# Access Compliance Report

## Public Rights-of-Way

Intersection ID: 23880	Main Street: CHINA GROVE CHURCH RD	Cross Street: STERLING LN	Location:	NW
ADA ID: 1DC77E1EC5BF	Ramp Type: PerpDiag	Initial Pass/Fail: Fail	Overall Compliance: No	Severity Score: 35
Codes/Mitigation Info/Possible Solution		Field Measurements/Component Compliance

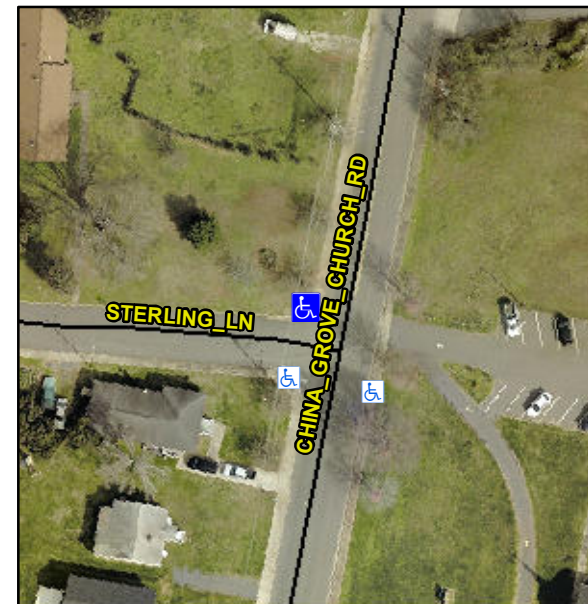
**Not Found, R304.5.1, R304.2.2, R304.5.3**

Compliance	Description	Data	Compliance	Description	Data
N/A	Ramp Length (in)	48.0	No	Ramp Slope (%)	14.4
No	Ramp Width (in)	46.0	No	Ramp XSlope (%)	4.9
N/A	Flare Type LT	N/A	N/A	Flare Type RT	N/A
N/A	Flare Slope LT (%)	N/A	N/A	Flare Slope RT (%)	N/A
N/A	Flare Traversable LT?	N/A	N/A	Flare Traversable RT?	N/A
N/A	Landing Length (in)	N/A	N/A	DWS Provided?	N/A
N/A	Landing Width (in)	N/A	N/A	DWS Contrast?	N/A
N/A	Landing Slope (%)	N/A	N/A	DWS Length (in)	N/A
N/A	Landing X Slope (%)	N/A	N/A	DWS Full Width?	N/A
N/A	Landing Curb? (Y/N)	N/A	N/A	DWS Offset (in)	N/A
N/A	Shared Landing?	N/A			
N/A	Gutter Ponding?	N/A	N/A	Gutter Slope (%)	N/A
N/A	Gutter Lip Ht (in)	N/A	N/A	Gutter X Slope (%)	N/A
N/A	Painted X Walk1?	No	N/A	Painted X Walk2?	No
	X Walk 1 Direction	To SW		X Walk 2 Direction	To SE
N/A	X Walk 1 Width (in)	N/A	N/A	X Walk 2 Width (in)	N/A
	X Walk 1 Slope (%)	0.6		X Walk 2 Slope (%)	1.0
	X Walk 1 X Slope (%)	7.0		X Walk 2 X Slope (%)	0.9

**Remove & Replace Curb Ramp With Two New Directional Ramps or Equivalent.**
